**ADDENDUM No.   1**

City of Austin

Project Name   Colorado St. Reconstruction and Utility Adjustments from 7<sup>th</sup> to 10<sup>th</sup> St.

C.I.P. No.   6961.002

UTILITY OVERVIEW MAP  
STA. 19+00 - 21+75

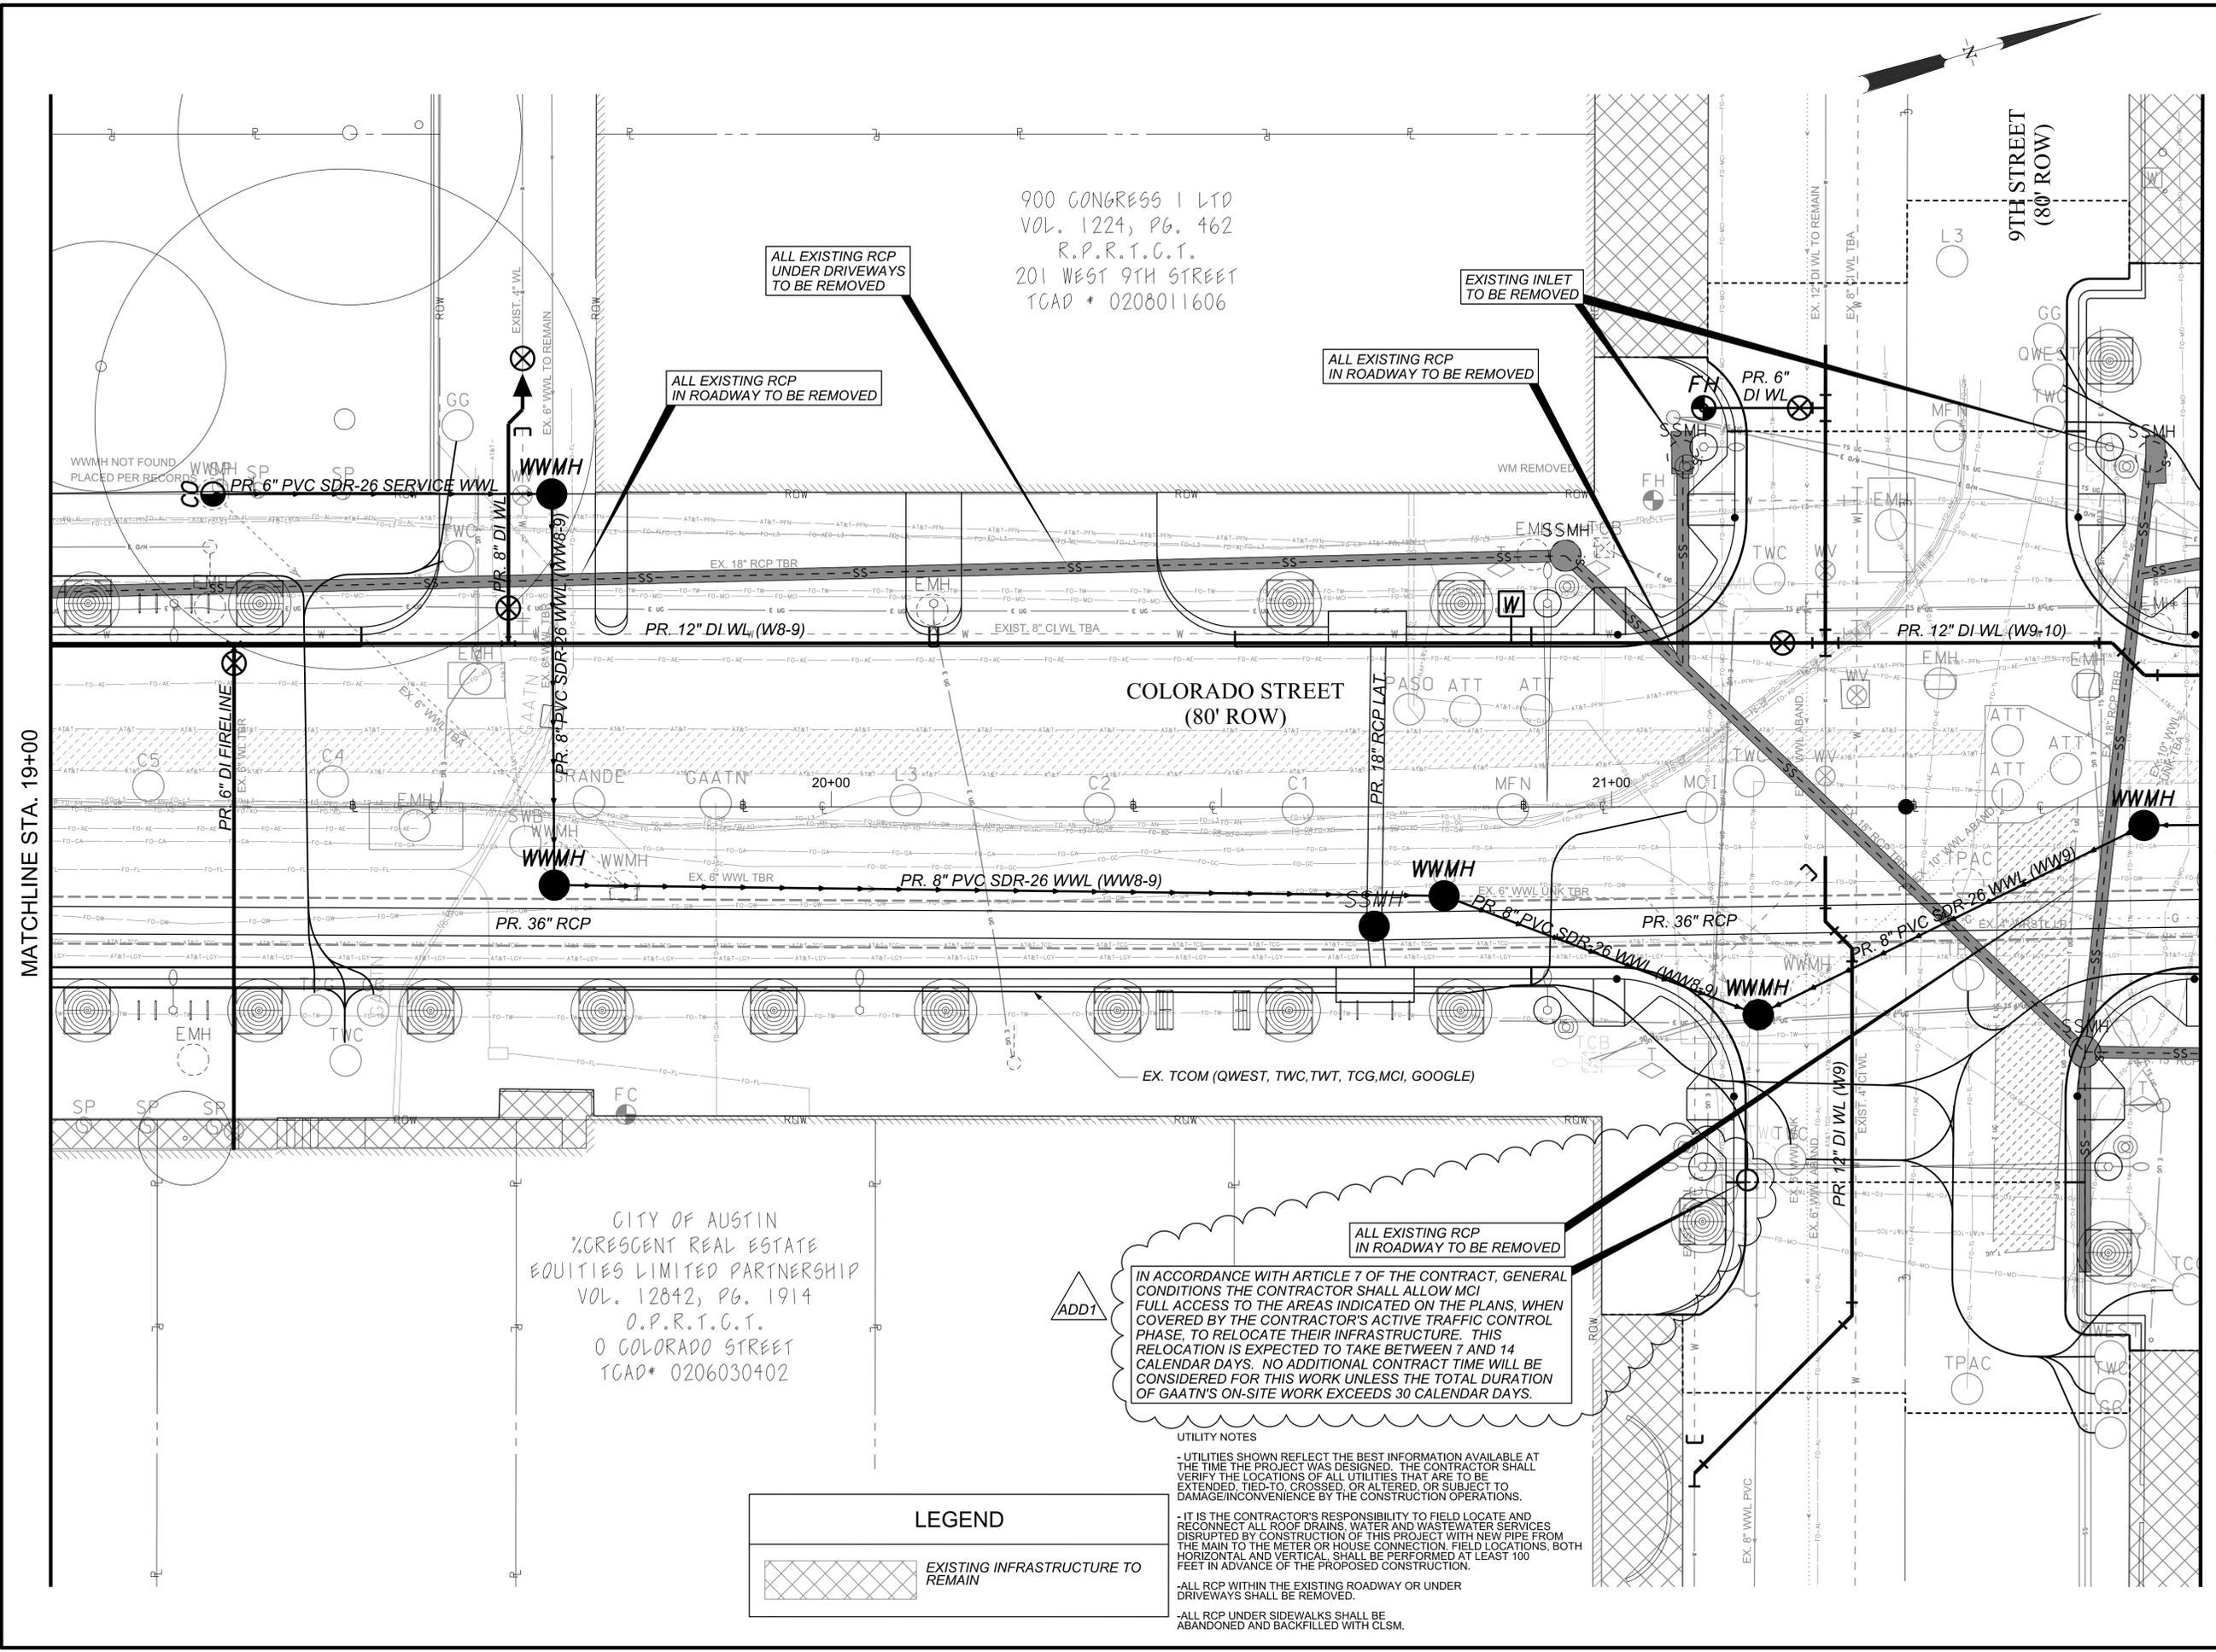
REV. NO.	DATE	REVISION DESCRIPTION
ADD. FR	05/05/15	MCI COORDINATION

IN ACCORDANCE WITH ARTICLE 7 OF THE CONTRACT, GENERAL CONDITIONS THE CONTRACTOR SHALL ALLOW MCI FULL ACCESS TO THE AREAS INDICATED ON THE PLANS, WHEN COVERED BY THE CONTRACTOR'S ACTIVE TRAFFIC CONTROL PHASE, TO RELOCATE THEIR INFRASTRUCTURE. THIS RELOCATION IS EXPECTED TO TAKE BETWEEN 7 AND 14 CALENDAR DAYS. NO ADDITIONAL CONTRACT TIME WILL BE CONSIDERED FOR THIS WORK UNLESS THE TOTAL DURATION OF GAATN'S ON-SITE WORK EXCEEDS 30 CALENDAR DAYS.

**TRAFFIC CONTROL PLAN  
7TH STREET - NW INTERSECTION PH1A/4C**

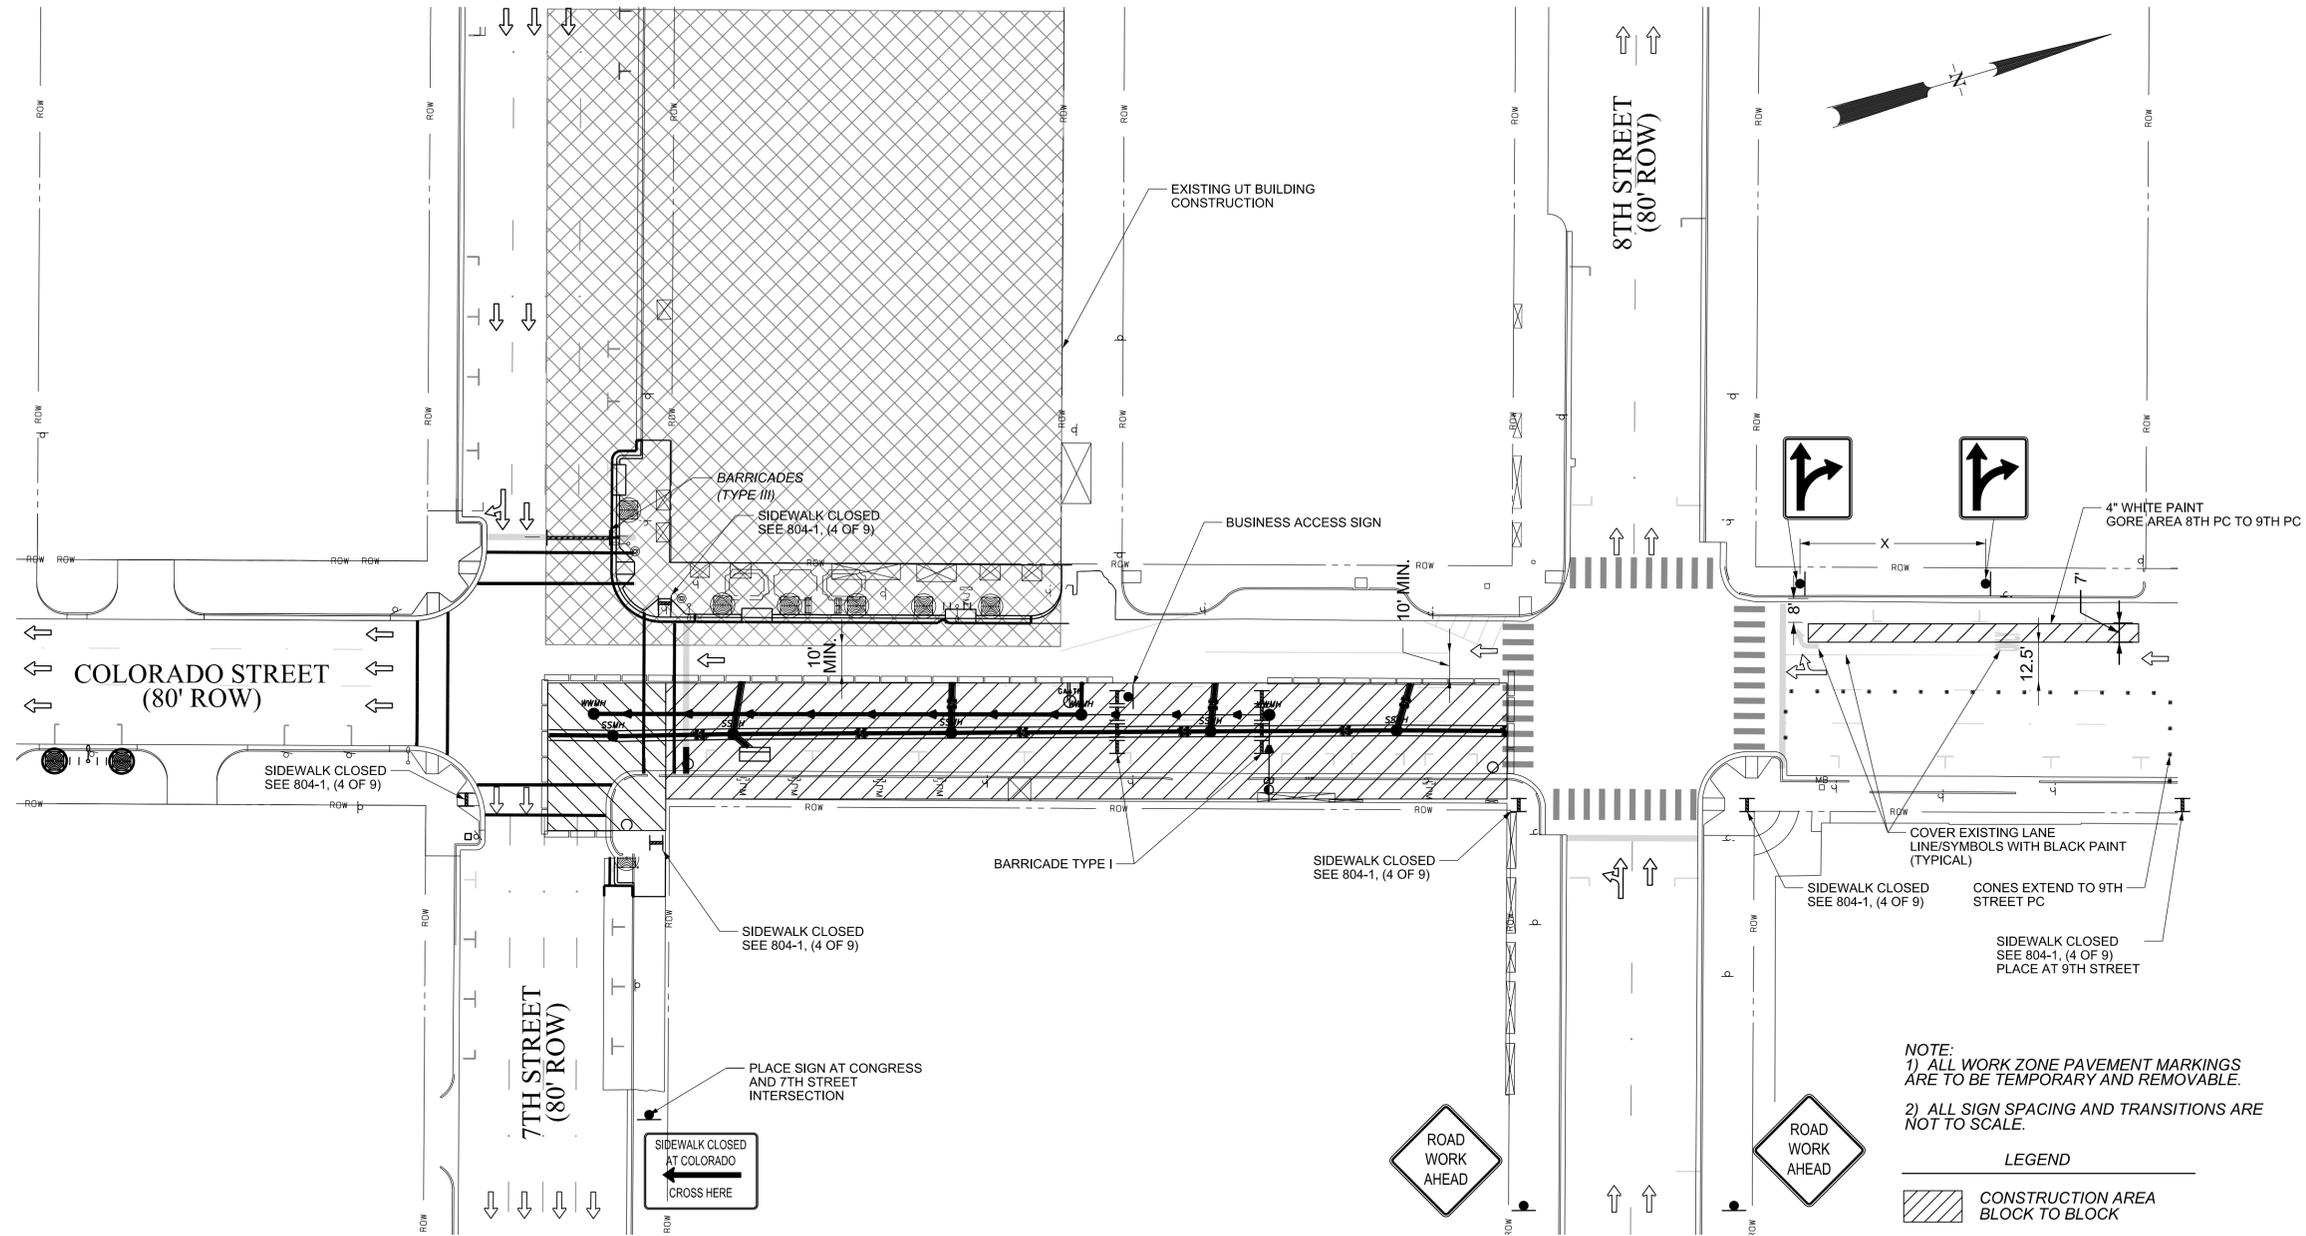
REV. NO.	DATE	REVISION DESCRIPTION
ADD. FR.	05/01/15	REPHASING OF TCP'S

NOTE:  
1) ALL WORK ZONE PAVEMENT MARKINGS ARE TO BE TEMPORARY AND REMOVABLE.  
2) ALL SIGN SPACING AND TRANSITIONS ARE NOT TO SCALE.  
3) THIS TCP TO BE SET FOR PHASE 4C PAVING INSTALLATION. PAVING WILL NOT BE DONE IN INTERSECTION DURING PH1A
